Re: **New Subdivision w/ 2 Wells & Tank (PR#34-2024)**
Martha's Vineyard Estates (PWS ID#01562)
Site Plan Approval

Thank you for your submittal to the Oregon Health Authority's Drinking Water Services (DWS) of plan review information for two new wells to serve the new *Martha's Vineyard Estates* subdivision. On February 26, 2024, our office received a "Tentative Subdivision Plan" showing the location of an existing well and the location of a 2nd well proposed to be constructed to serve a new 8-lot subdivision located northwest of McMinnville in Yamhill County. On March 6, 2024, we received the land use application submitted to Yamhill County. A plan review fee payment in the amount of \$825 was received on March 8, 2024 under plan review # 34-2024, which is trackable online at:

- SRC-AA Well #1 – [L149436, YAMH59159](#) constructed 11/30/2022 on Lot 3 and
- SRC-AB Well #2 proposed to be constructed on Lot 1 as shown in the following maps:

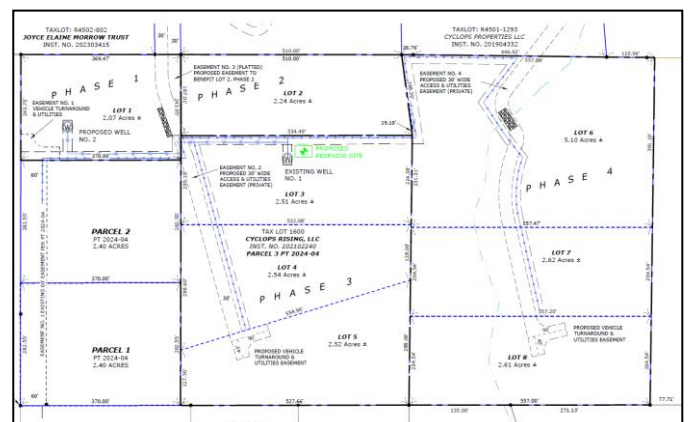
A regional geologist in our program, Tom Pattee, reviewed the well log for well #1 (YAMH59159) and the proposed well #2 location. Mr. Pattee noted the following, which should be shared with the well driller:

- Well #1 (L149436):

Comments: This well was drilled to a depth of 401 ft. The casing and casing seal extend to a depth of 101.5 ft, 17 ft into low permeability basalt that overlies the aquifer. A narrow diameter liner and liner screen extend to the bottom of the hole and helps keep the borehole open below the casing. Water can enter the well through the uncased portion of the well below a depth of 101.5 ft. Sensitivity Analysis results suggest that well construction does not contribute to the overall sensitivity of this water source to local land use practices.

Comments: This well is designed to capture water from a deep confined layered basalt aquifer. The water-bearing zone is reported to occur at a depth of 217 ft and is overlain by 133 ft of low permeability basalt that acts as a confining layer. Water within the aquifer is under pressure, rising 118.5 ft above the water-bearing zone to a recorded depth of 98.5 ft below ground level. Sensitivity Analysis results suggest that the aquifer is not highly sensitive to nearby land use practices.

Hydrogeologist comments regarding Waiver from Construction Standards Request: A property line boundary is present within the 100 ft sanitary setback. The well is adequately constructed to draw water from a deep confined layered basalt aquifer. Sensitivity Analysis results suggest that water quality from this drinking water source has a low susceptibility to activities associated with future residential development.

- Well #2 (Proposed):

Estimated depth to water-bearing zone: ~180 to 230 ft

Estimated depth of casing seal: 50 ft or deeper.

Comments: Based on the well log for the nearby Martha's Vineyard Estates 2022 Well #1 (YAMH59159), it is likely that a well drilled at this location will draw water from a deep confined basalt aquifer. The depth to competent bedrock is likely to be 45 to 90 ft.

The project is granted site plan approval. Once construction of Well #2 is complete, please submit the following for both wells and related subdivision:

1. The well driller's report (well log).
2. Well pumping test information including static water level, pumping rate, draw-down and rate of recovery.
3. Pump information (e.g., type of pump, make/model, capacity, and lubricant used).
4. Documentation showing ownership or easements for 100-ft radius around both wells.
